City Hall/Town Hall

December 7, 2015

Del Mar City Council

Project Status

Cross Section

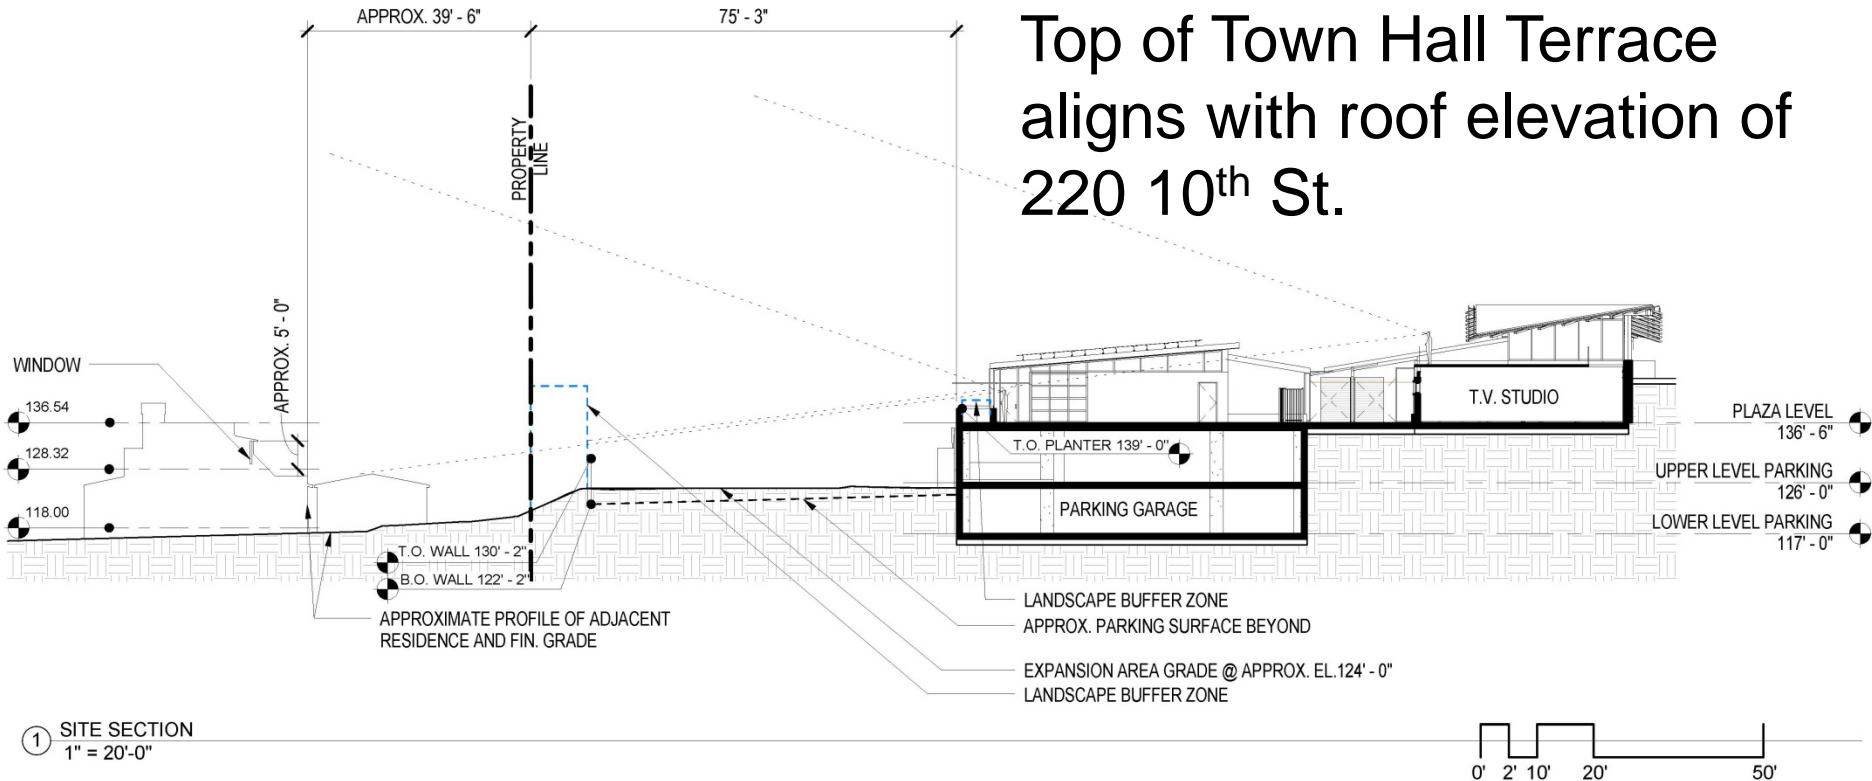
Expansion Area B/Town Hall Terrace

- Concerns about:
 - Noise
 - Privacy
 - Future use of Town Hall Terrace

Town Hall Terrace/Expansion B

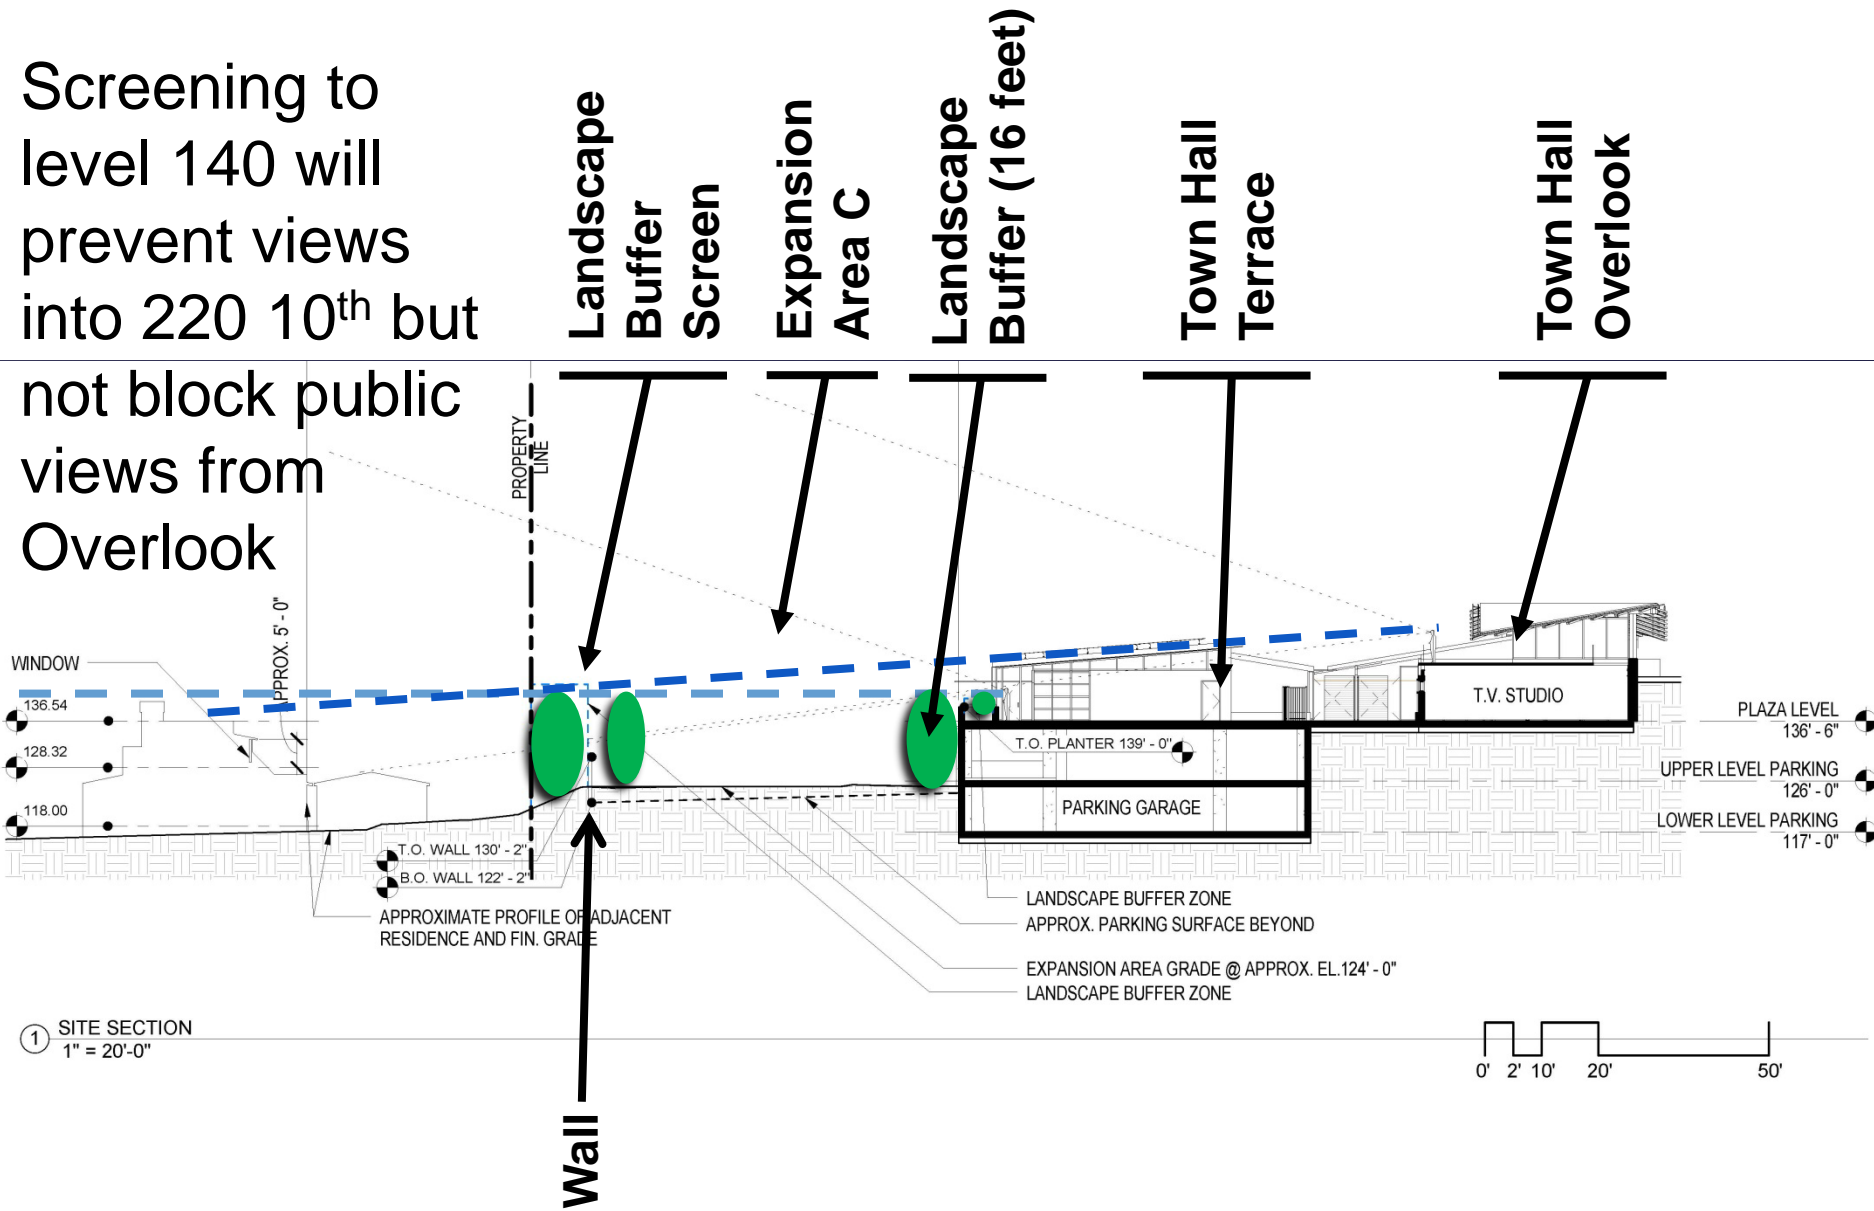
Suggested measures to provide better screening and privacy

1. Additional Screen Planting along edge and at parking structure
2. Add gate to limit access

Screening to level 140 will prevent views into 220 10th but not block public views from Overlook

Town Hall Terrace/Expansion B

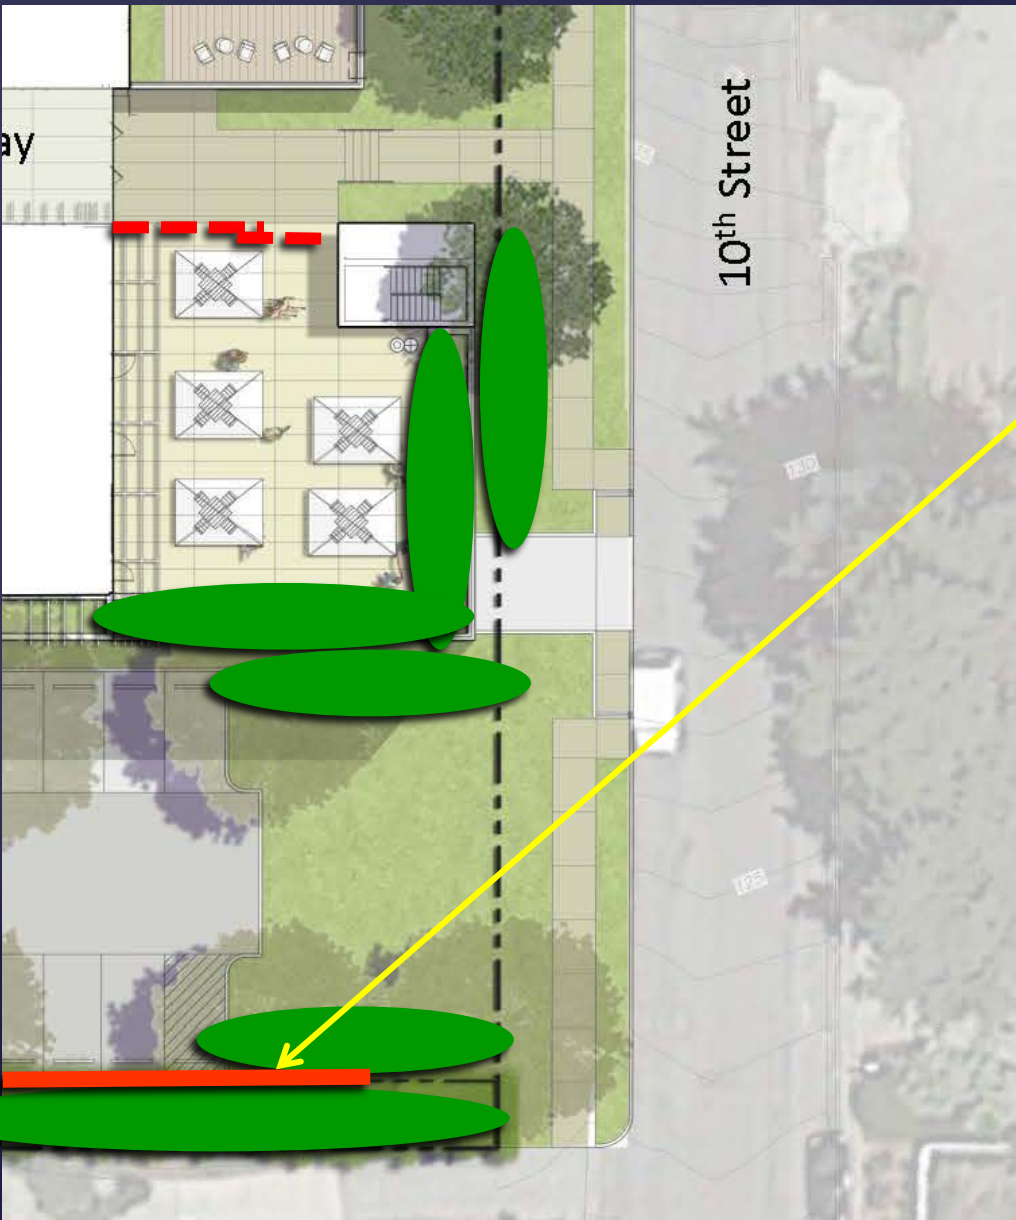
1. Additional Screen Planting along edge and at parking structure
2. Add gate to limit access
3. Extend wall to corresponding residential front yard setback; make wall 10-feet tall

Town Hall Terrace/Expansion B

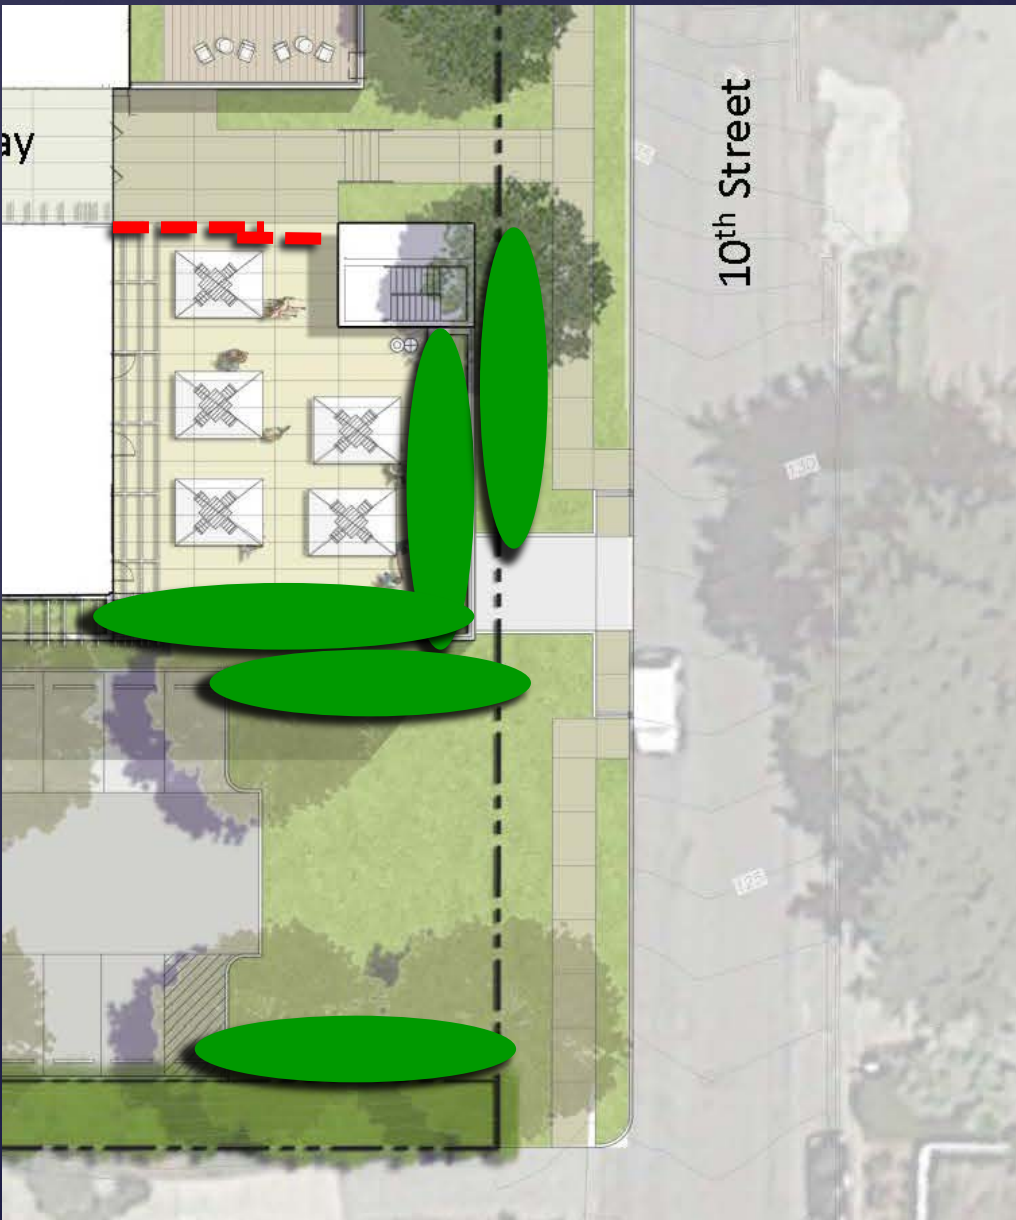
1. Additional Screen Planting along edge and at parking structure
2. Add gate to limit access
3. Extend wall; make wall 10-feet tall
4. Reduce useable size by approximately 50% to keep away from southwest corner

Town Hall Terrace/Expansion B

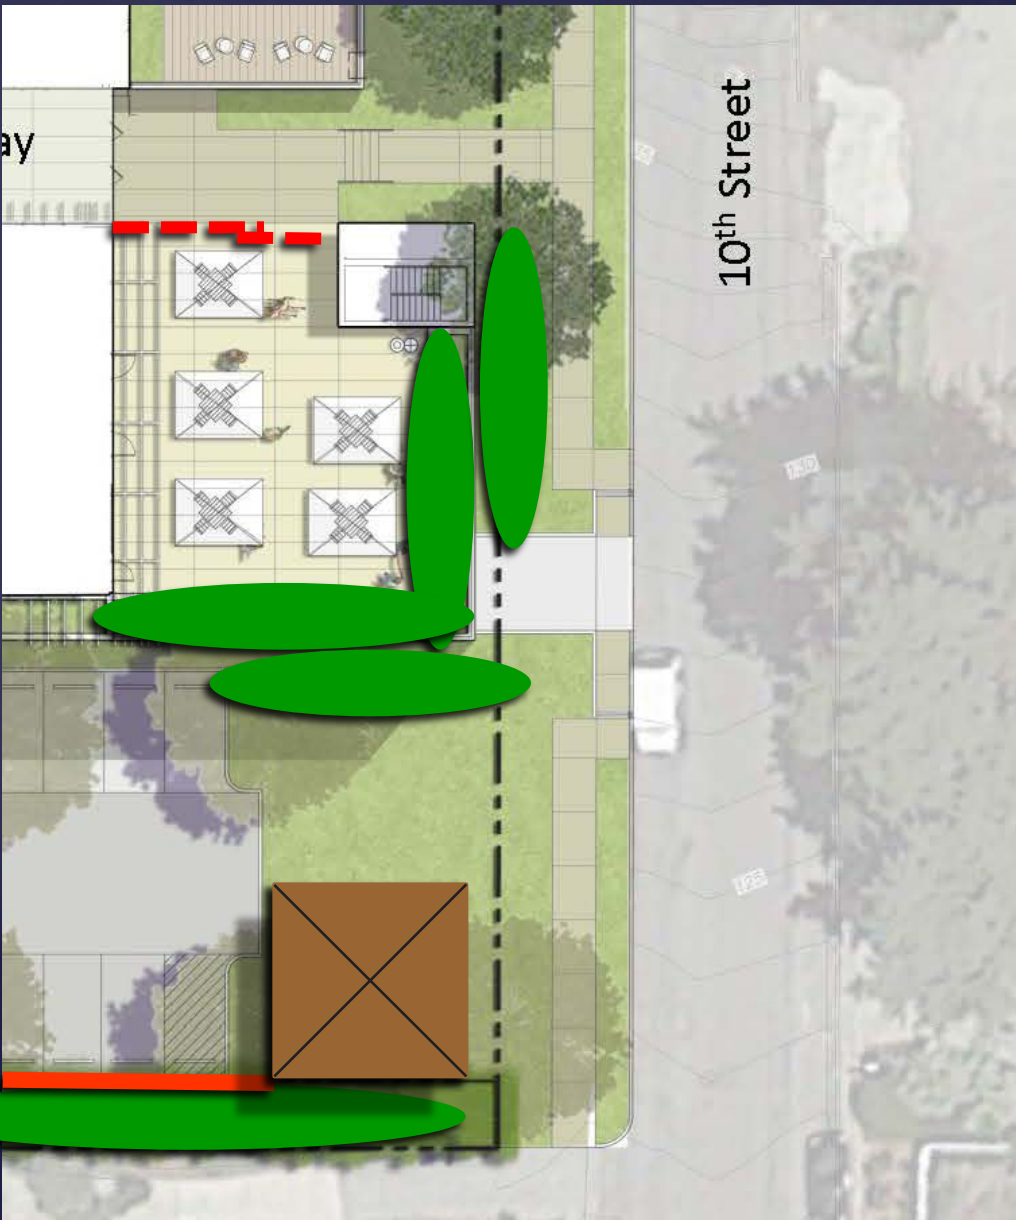
1. Additional Screen Planting along edge and at parking structure
2. Add gate to limit access
3. Extend wall; make wall 10-feet tall
4. Reduce useable size
5. Do not use except as walkway
6. Limit use of Terrace

Town Hall Terrace/Expansion B

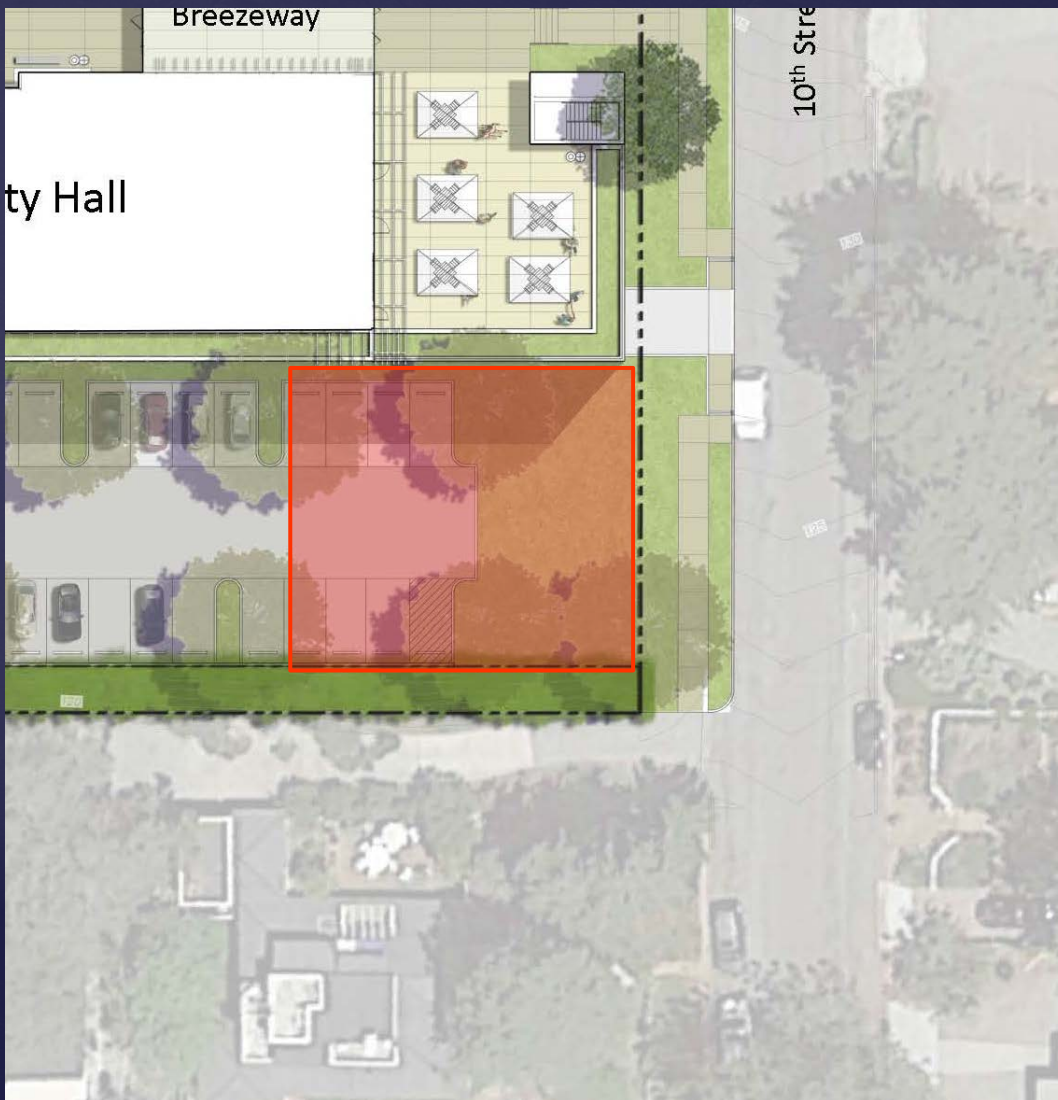
1. Additional Screen Planting along edge and at parking structure
2. Add gate to limit access
3. Extend wall; make wall 10-feet tall
4. Reduce useable size
5. Do not use except as walkway
6. Limit use of Terrace
7. Alvarado House in Expansion C to increase privacy.

Expansion Area C (southwest corner)

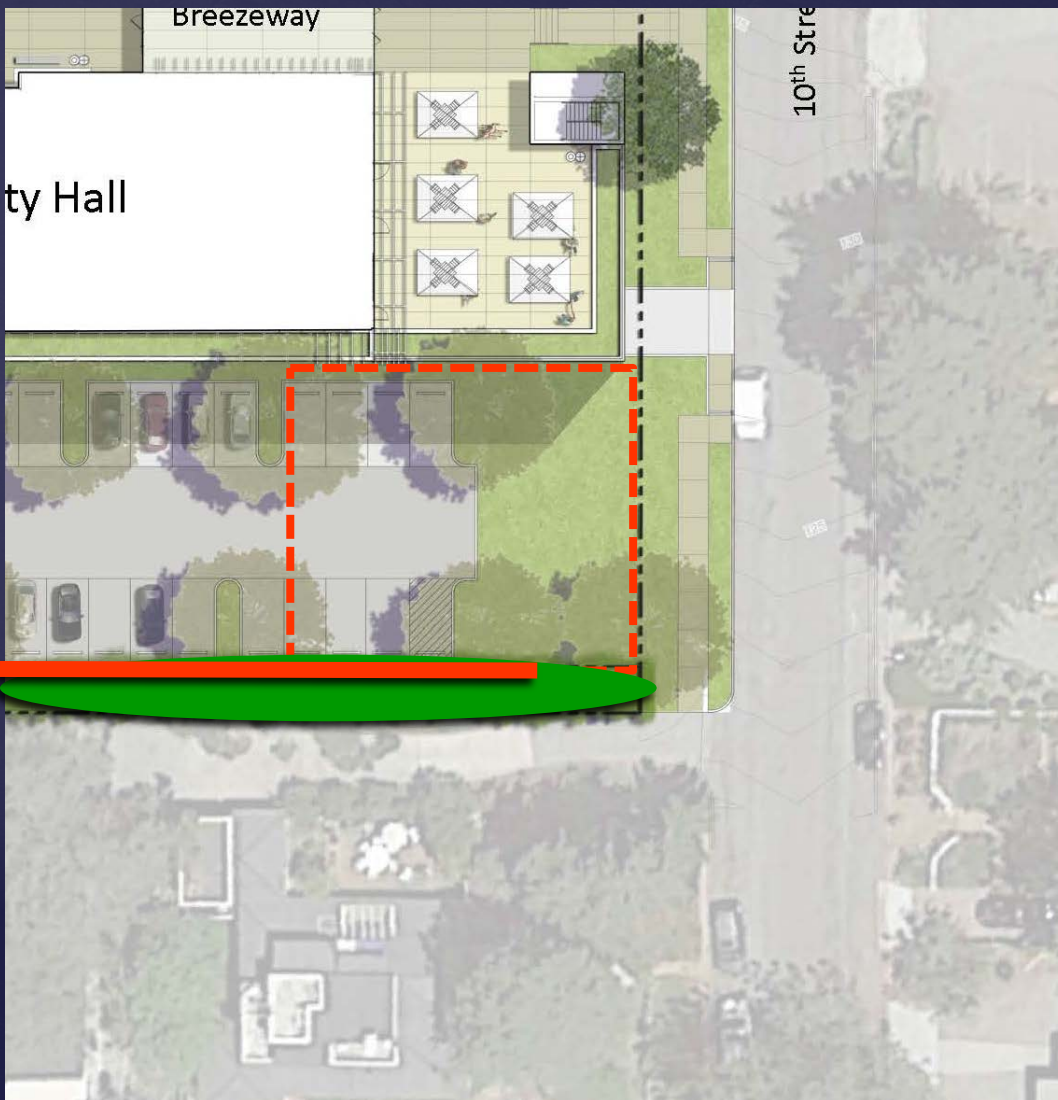
Concerns about:

- Size
- Parking in Expansion Area
- Alvarado House

Expansion Area C

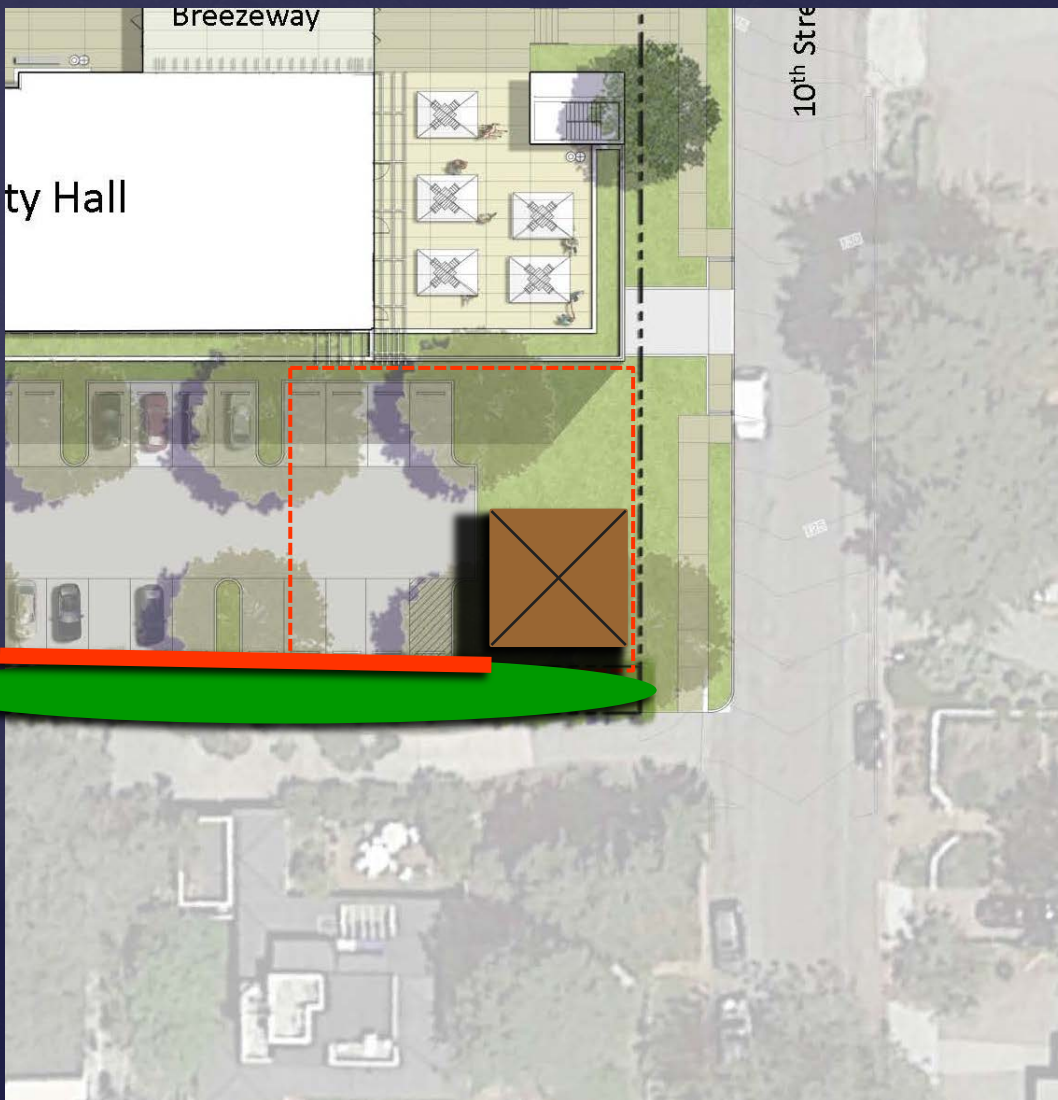
1. Additional Screen Planting along edge of wall, custom to each owner
2. Residential front yard style landscape
3. Raise wall to 10-feet tall
